## ADDENDUM 2

DATE: November 4, 2024  
COMM NO: 24016  
PROJECT: Lewis Gale Medical Center Second Floor Renovation

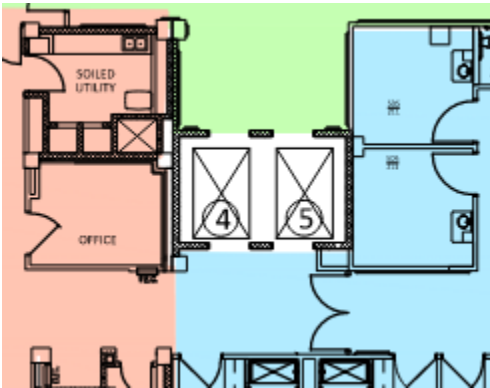
4. **Mechanical: Note 22 on Sheet AD-3 and Note 19 on A1-3 say to remove and replace the grille, control valve, isolation valves, countertop, and panels and panel trim. The mechanical or plumbing plans do not call out for the valves to be replaced. What is the correct scope of work being done at the window units in ASU?**

The project scope includes replacement of the control valves at the unit ventilators, and the isolation valves. We call for the existing pneumatic controls to be replaced with new digital controls, which would include the control valves. The contractor will need to test the existing system to determine the existing water flows, and the new control valves will need to be balanced to match the existing water flows.
